SAND CREEK RESTORATION

PCD PROJECT NUMBER: CDR-20-004

PUBLIC IMPROVEMENT CONSTRUCTION PLANS

EPC STORMWATER REVIEW COMMENTS
 IN ORANGE BOXES WITH BLACK TEXT

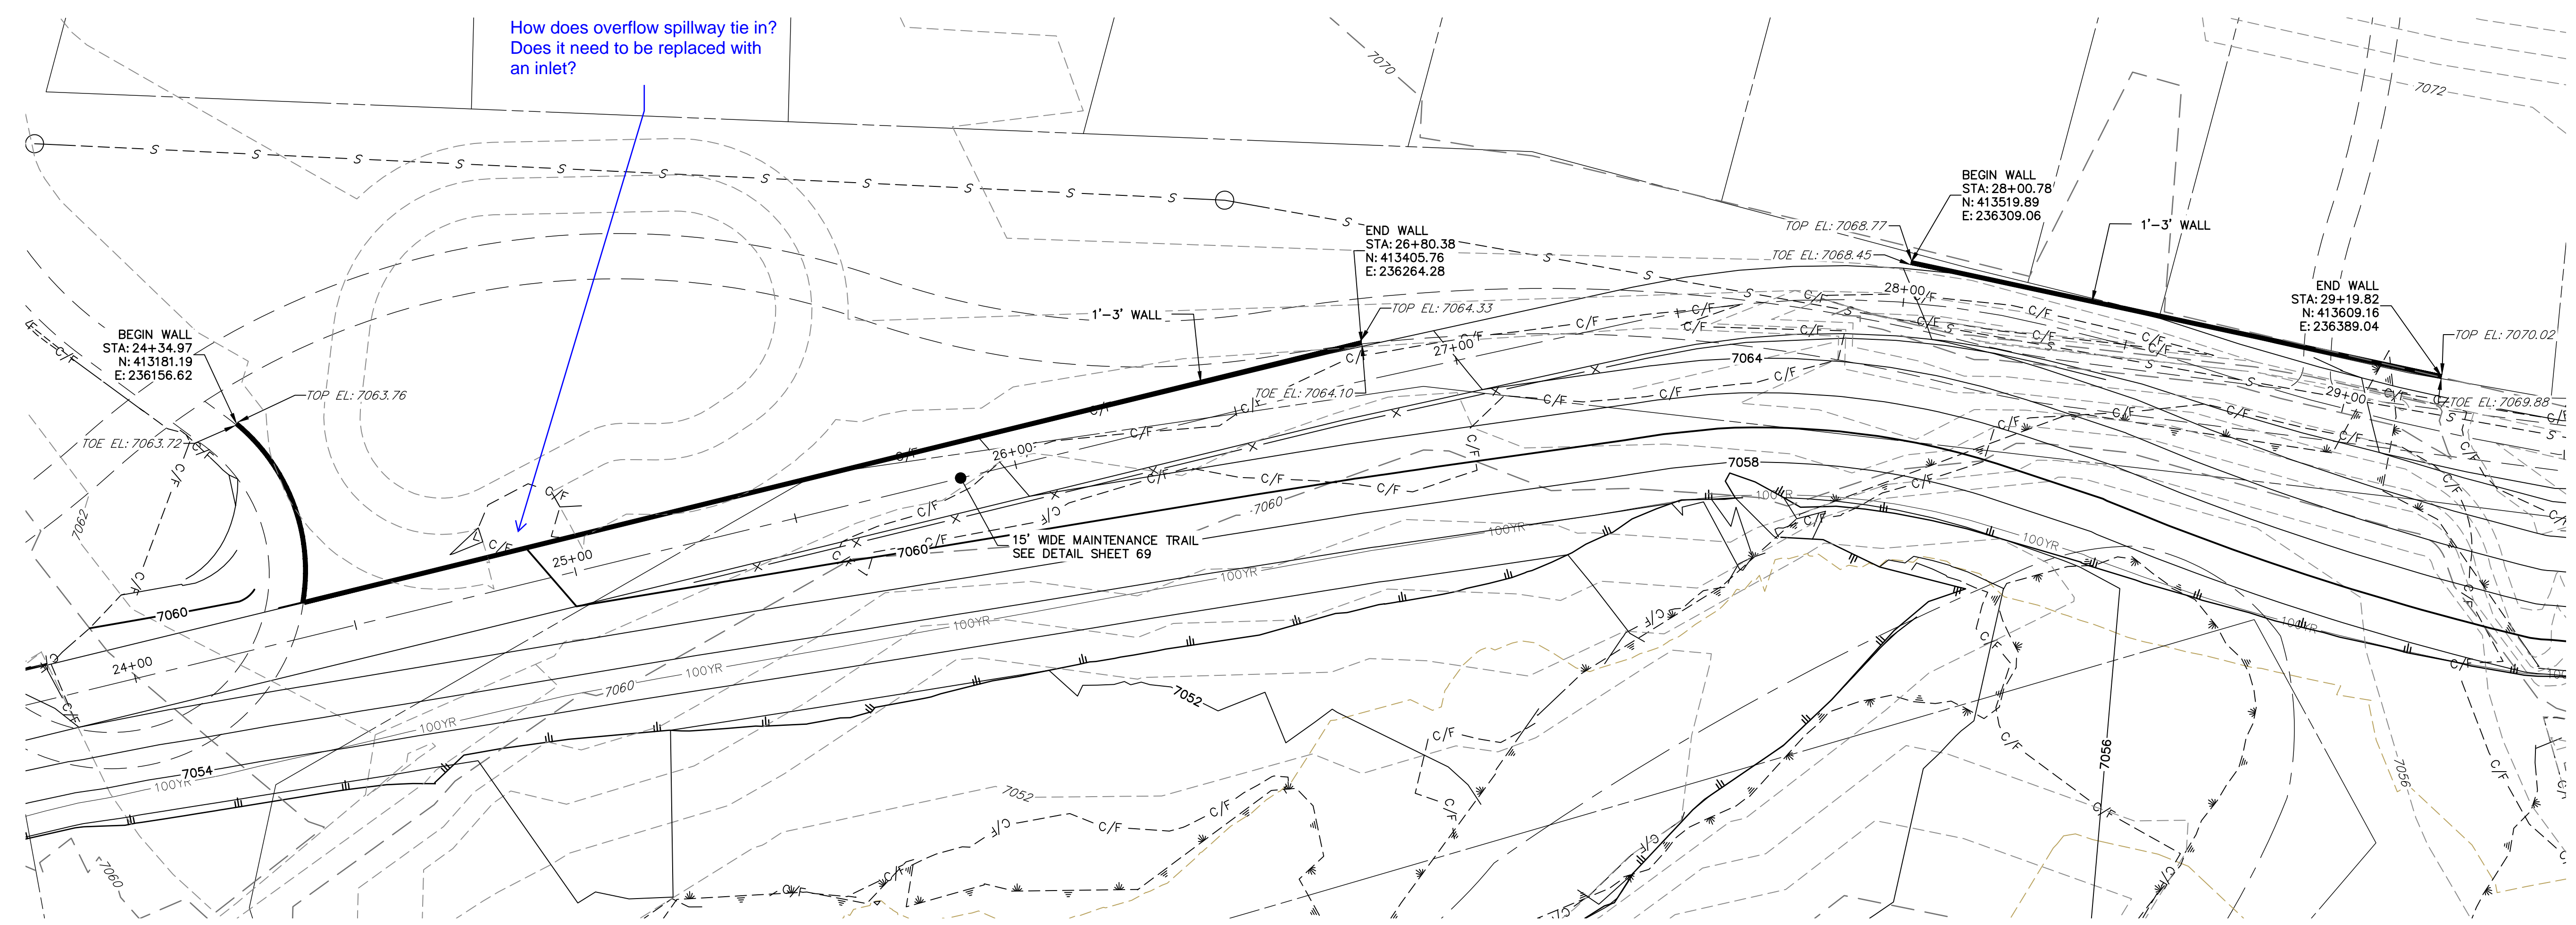
How does overflow spillway tie in? Does it need to be replaced with an inlet?

JR-Primary outlet is a pipe that discharges into the existing 60" RCP south of the Sand Filter. The walls have been revised to tie into the sand filter berm and allow the spillway to overflow across the maintenance trail into Sand Creek.

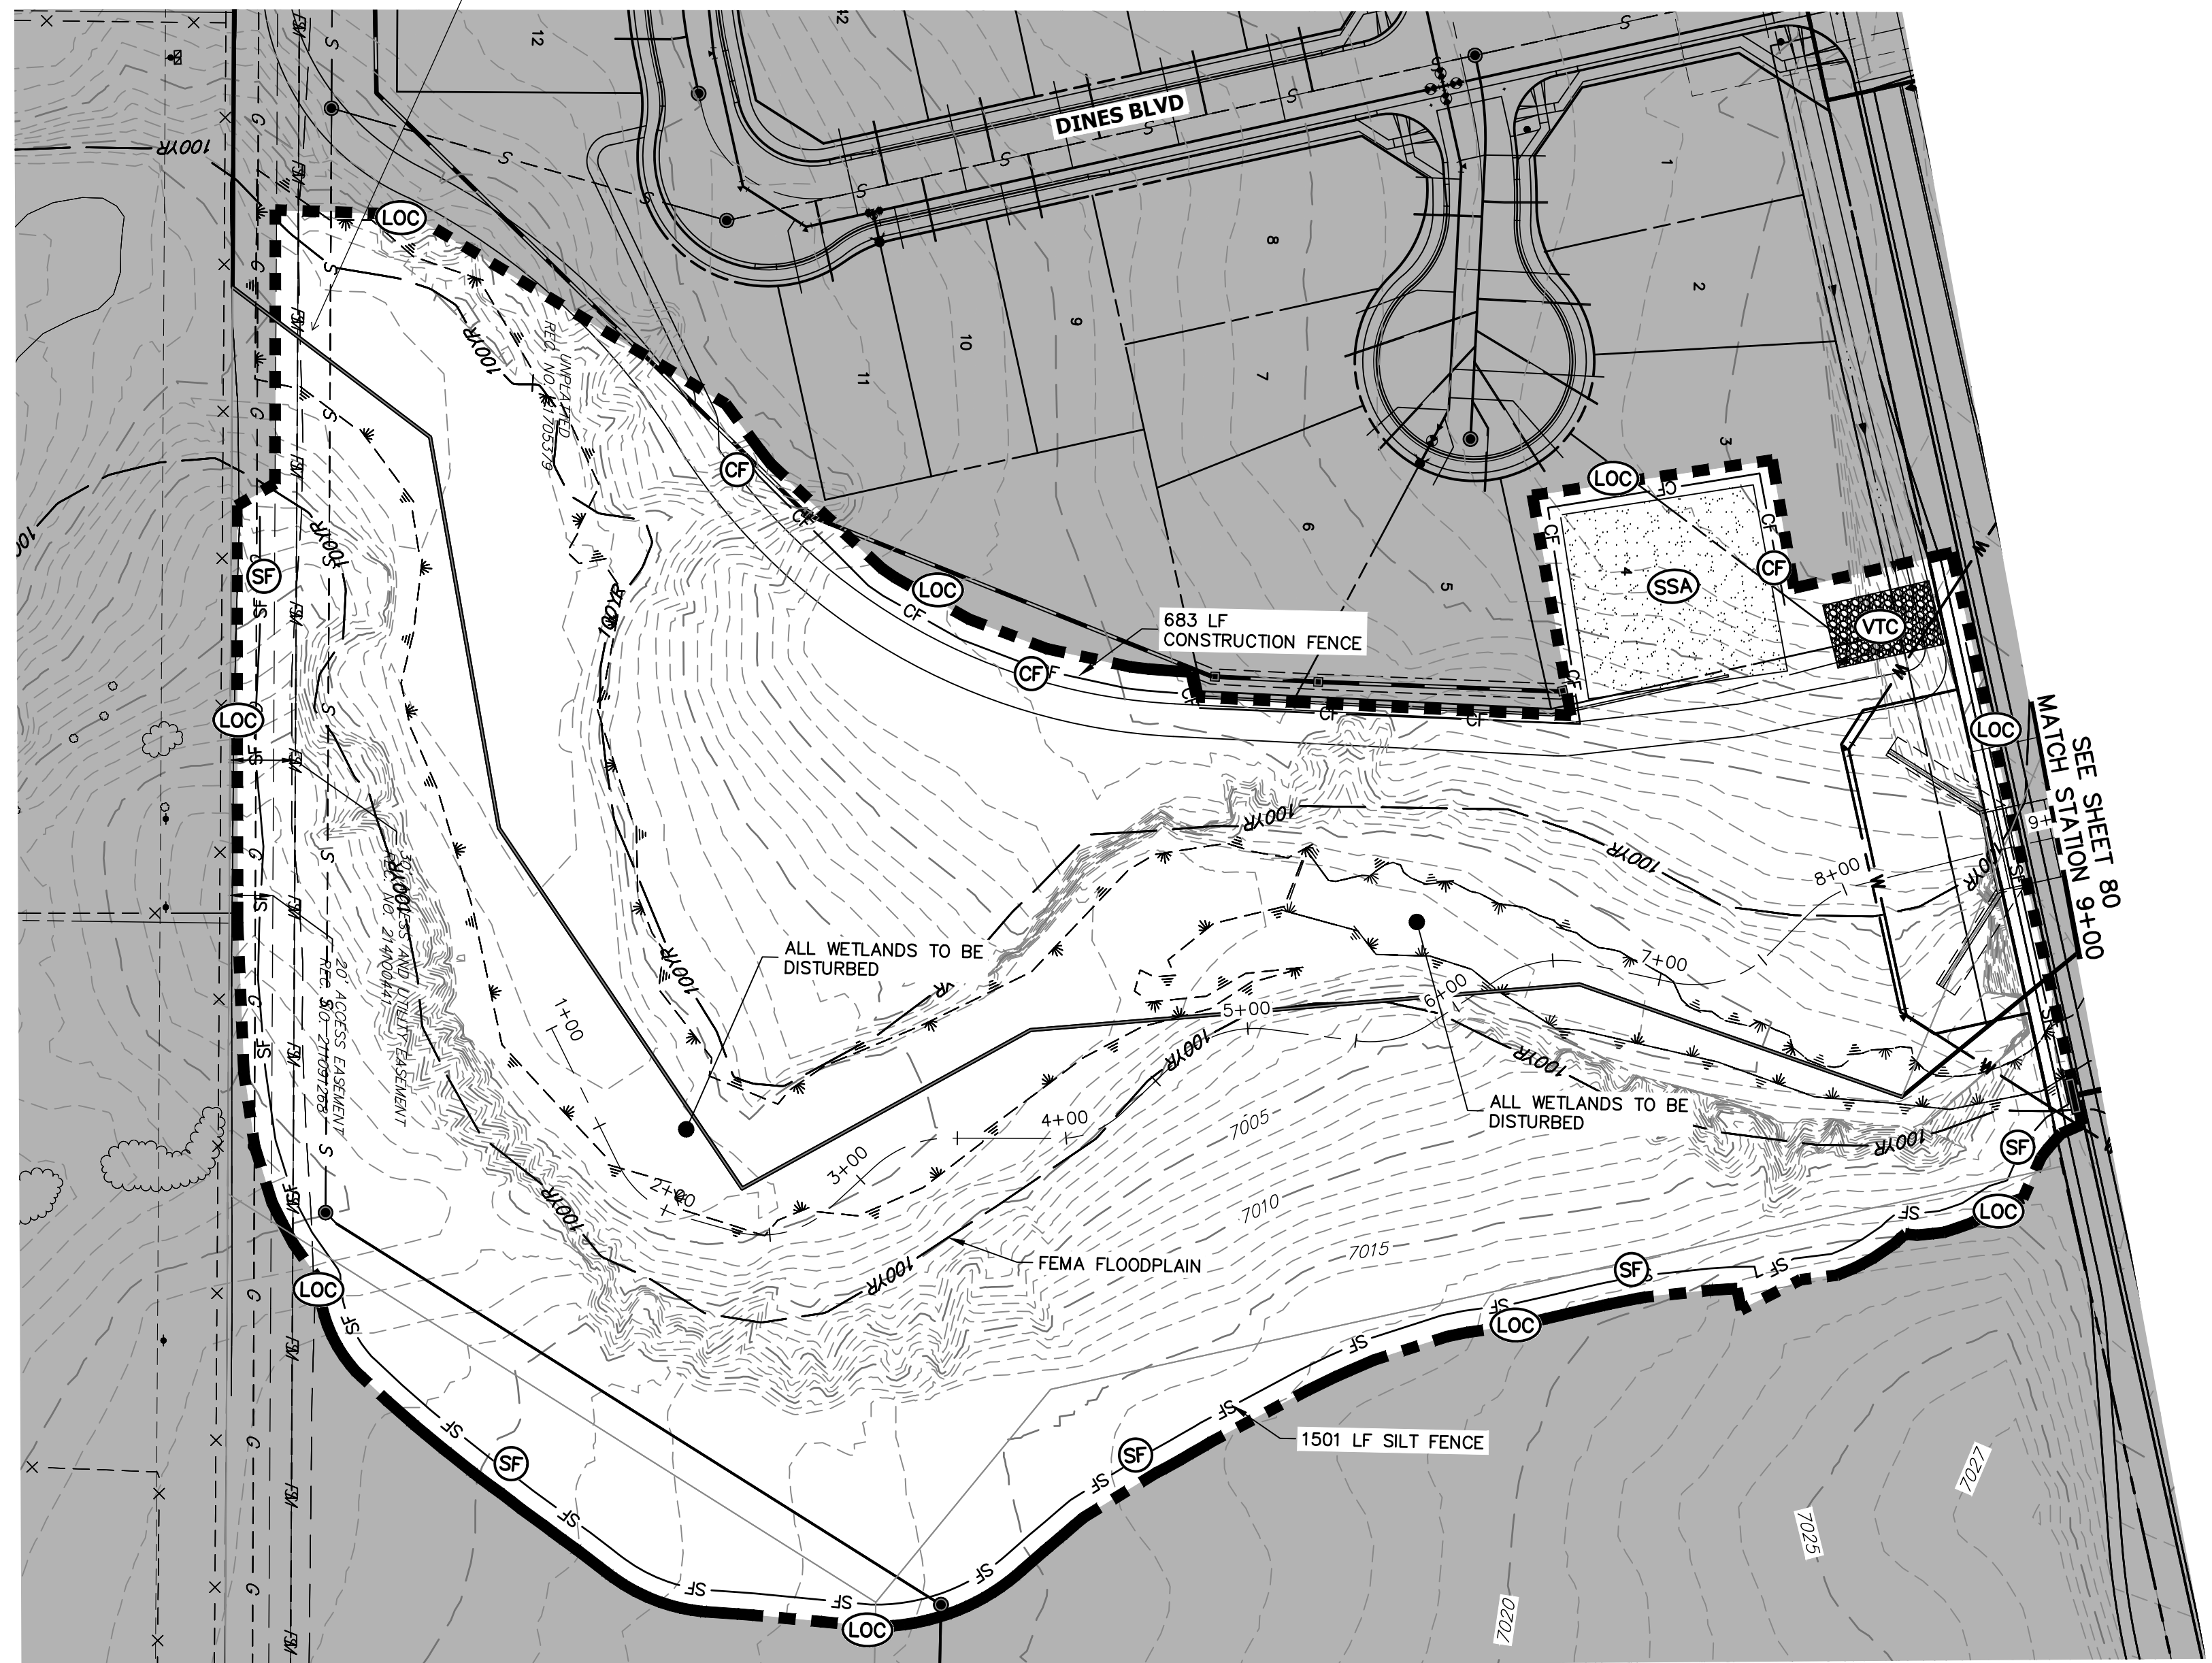
install temporary BMPs to prevent sediment from migrating down stream

JR-Addressed, check dams have been added

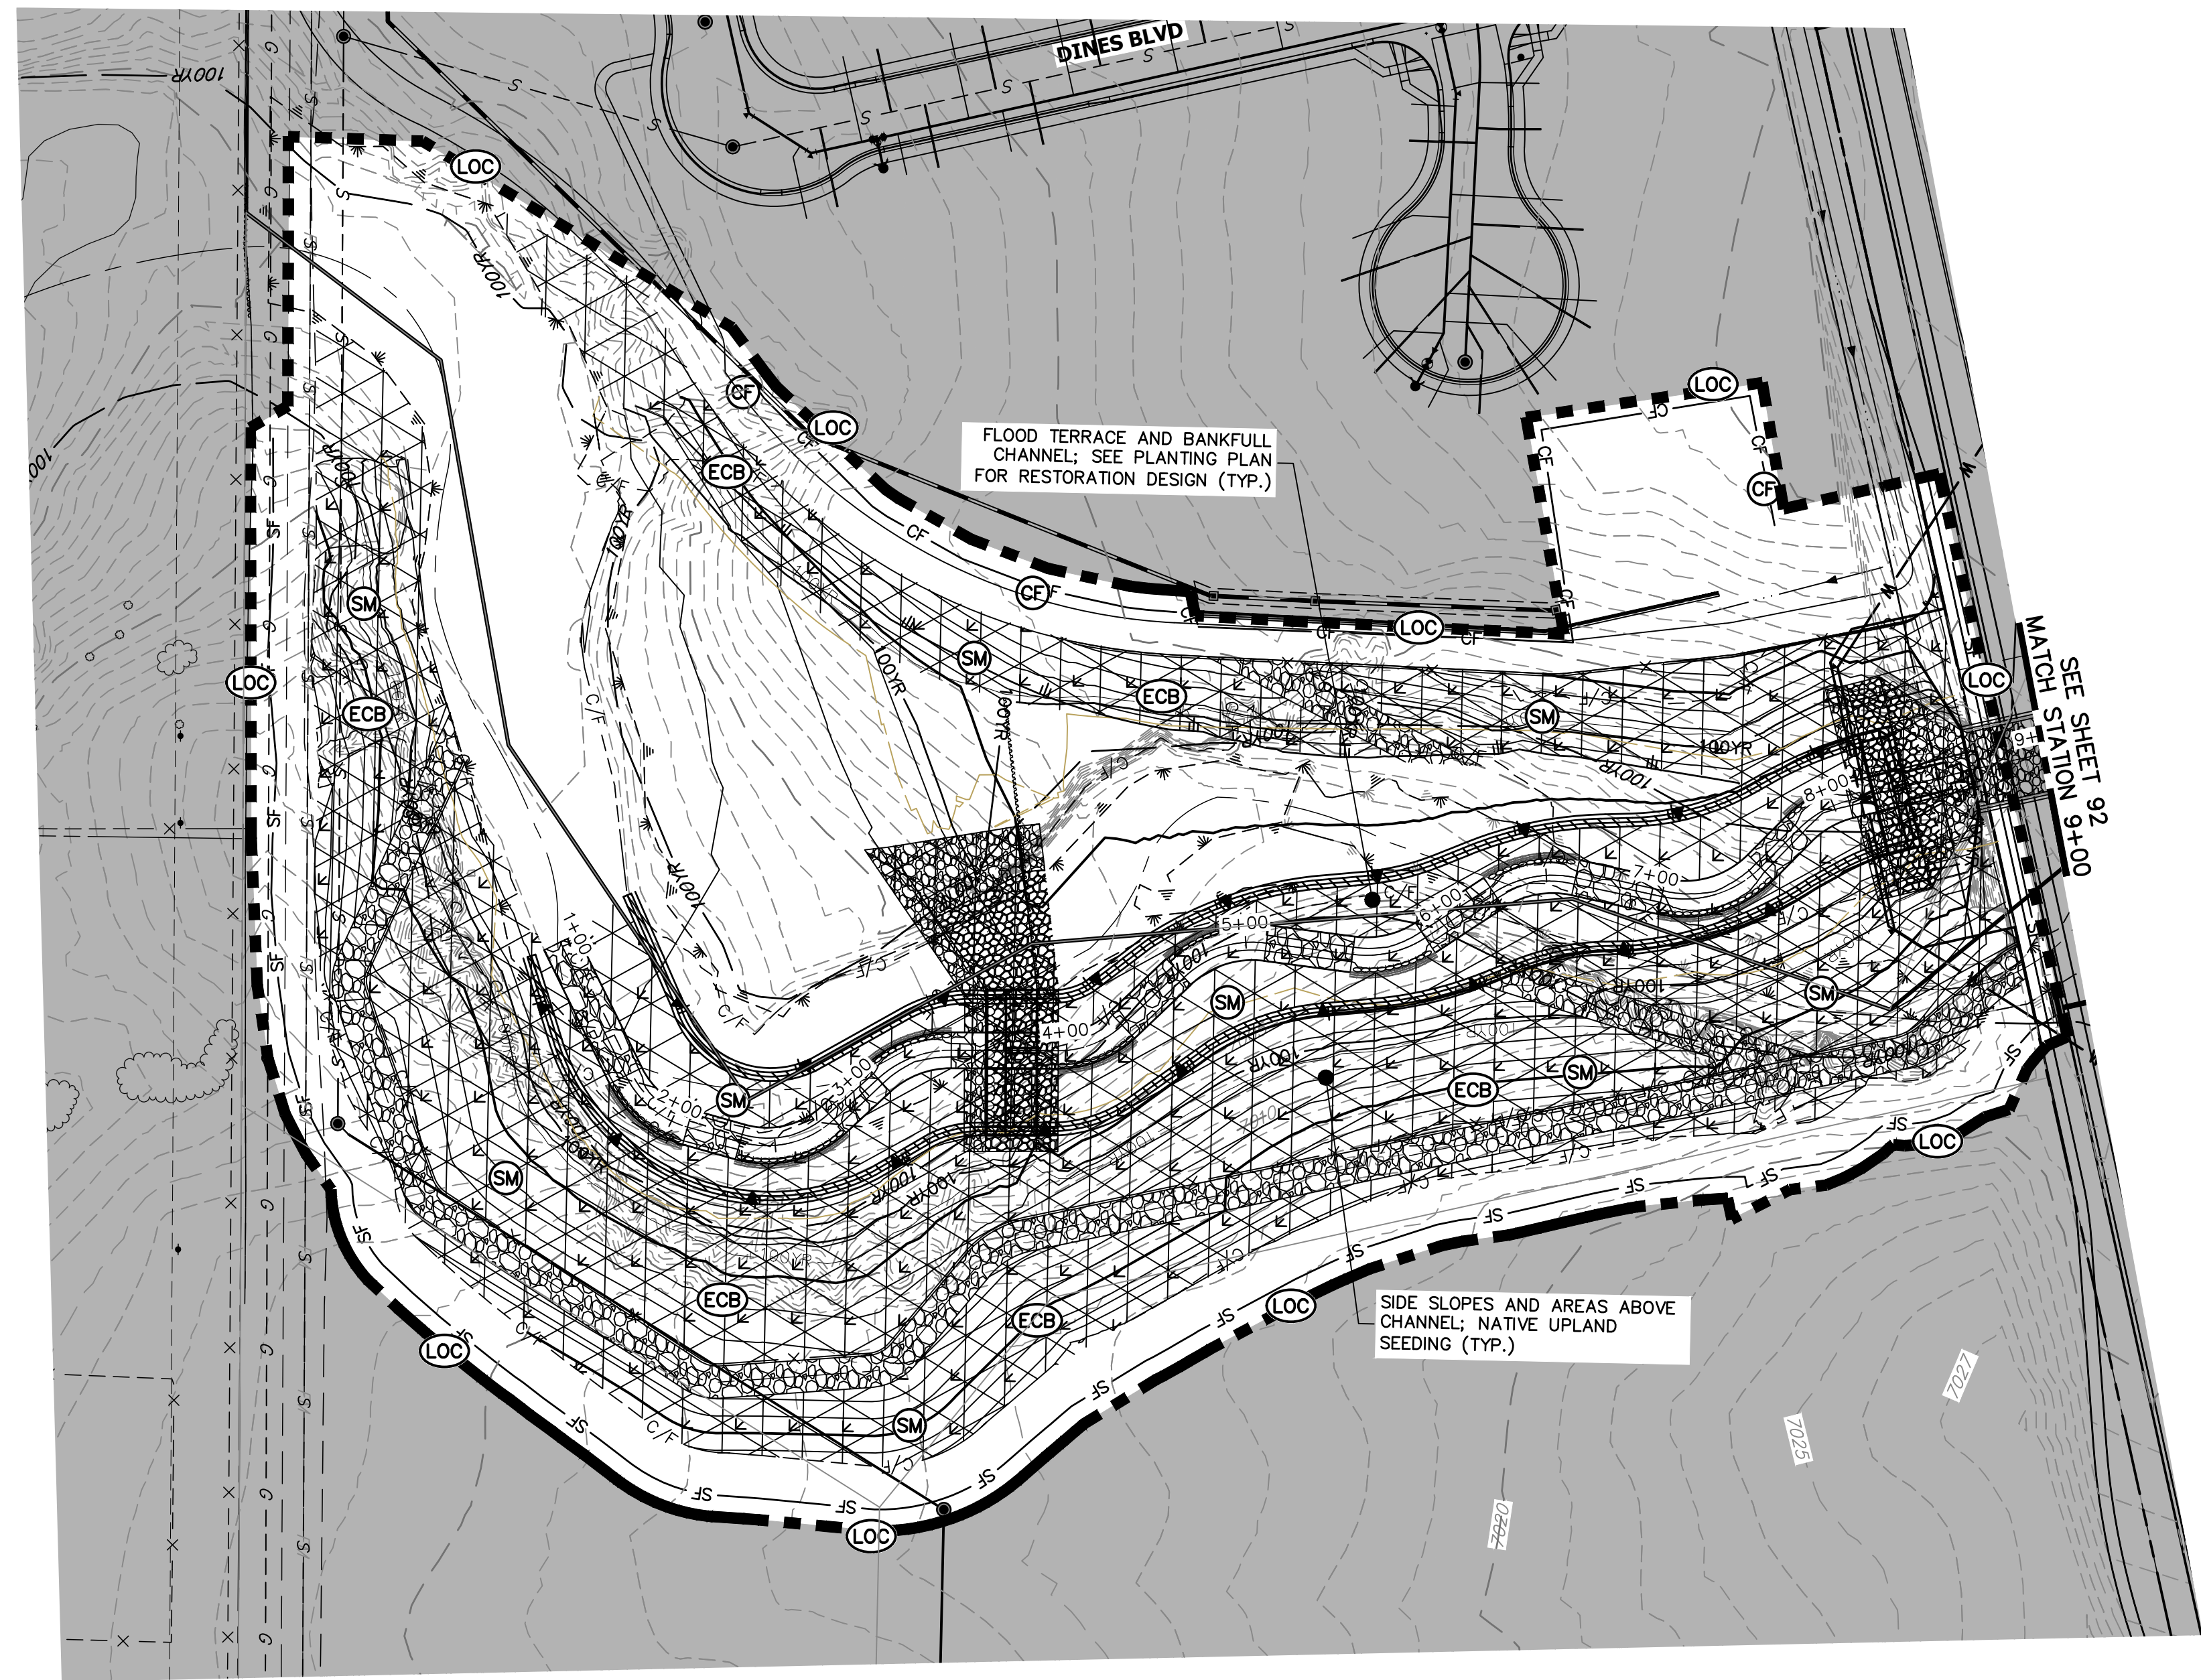
final should have all temporary BMPs removed (or grayed out) from the figures
